DRAFT

April 27, 2022

**Re: Peer Review of Noise Impact Assessment
Nelson Aggregate Quarry Extension
Burlington, Ontario**

At the request of the Region of Halton, J.E. COULTER ASSOCIATES LIMITED has conducted a peer review of the Noise Impact Assessment Study for the Nelson Aggregate Quarry Extension, prepared by HGC Ltd., dated November 15, 2021 and April 22, 2020. The Acoustic Assessment Report of the Halton Asphalt Supply located in the quarry, dated April 27, 2021 and February 7, 2020, was also reviewed. The Planning Justification Report and ARA Statement dated April 2020 mentions that Nelson Aggregate Co. is applying for a maximum tonnage of 2 million tonnes per year; however, they plan on extracting an average of 1 million tonnes per year. We understand the idea behind the larger figure is that occasionally there might be a surge in volume and the surge would be taken up by the larger figure. As per MECP's *NPC 300*, the evaluation should be for the predictable worst case, which would be the peak of the surge of 2 million tonnes per year.

File Name: Operational Plan

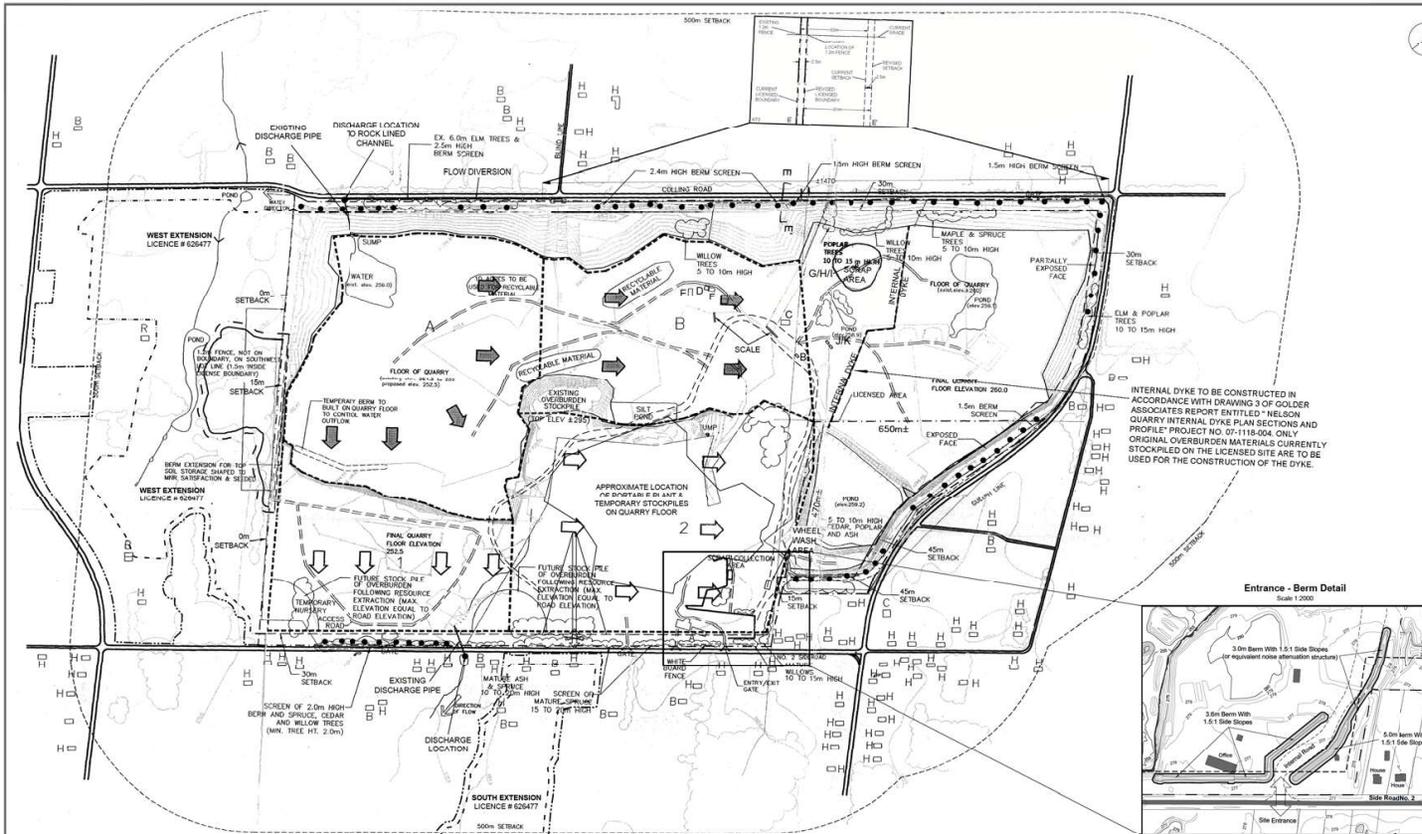
The Nelson Aggregate quarry is located at 2433 No. 2 Side Road, Burlington. It is bounded by Guelph Line to the west, No. 2 Side Road to the south, Cedar Springs Road to the east, and Colling Road to the north. See Figures 1 and 2 in Appendix for a Key plan.
